## Errata 6

# Archer Forward: Campus Preservation and Improvement Plan Final Environmental Impact Report

This Errata to the Final EIR (referred to herein as Errata 6) addresses specific corrections to the Final EIR and provides additional clarifications regarding the proposed three-year construction schedule for the Project. The Draft EIR, Final EIR, Errata 1, Errata 2, Errata 3, Errata 4, Errata 5, and this Errata 6 comprise the EIR for the Project.

Revised DPM Construction HRA AERMOD  
Annual Scalar Concentration Isopleth

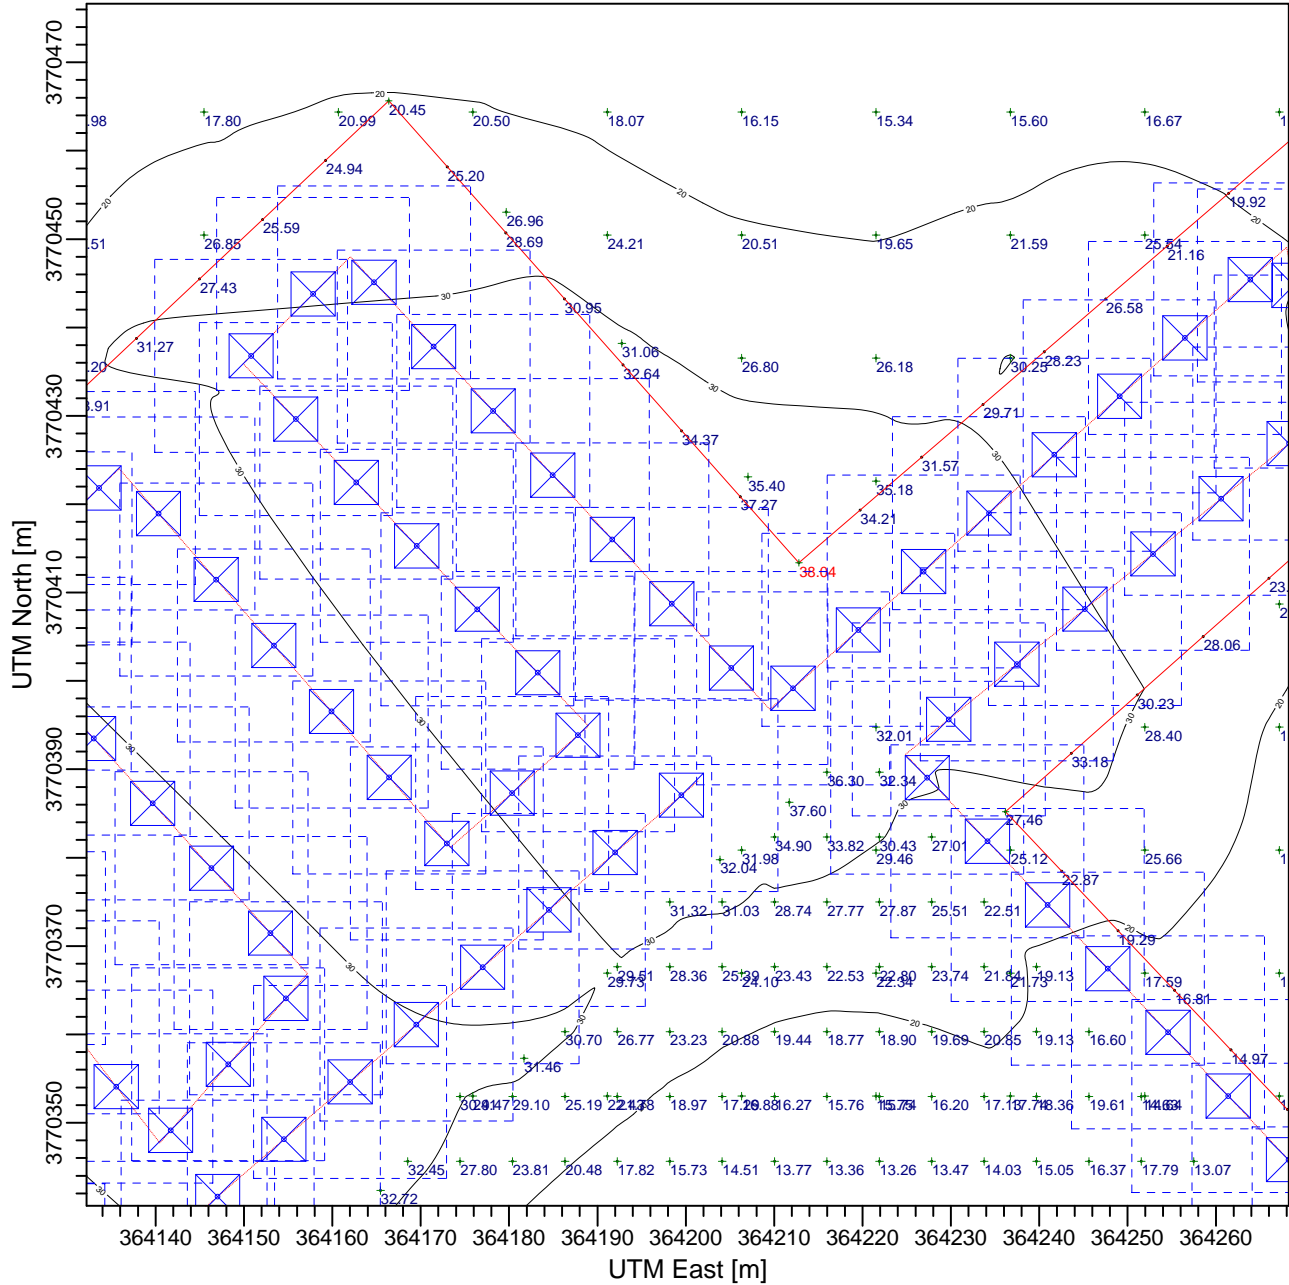
Final EIR, Volume 6, Appendix F-2, Supplemental Air Quality Worksheets, Appendix F.1-1(d), Updated Construction Diesel Particular Matter (DPM) Exhaust Emissions Health Risk Assessment (HRA), replace the DPM Construction HRA AERMOD Annual Scalar Concentration Isopleth with the revised DPM Construction HRA AERMOD Annual Scalar Concentration Isopleth attached to this Errata 6.
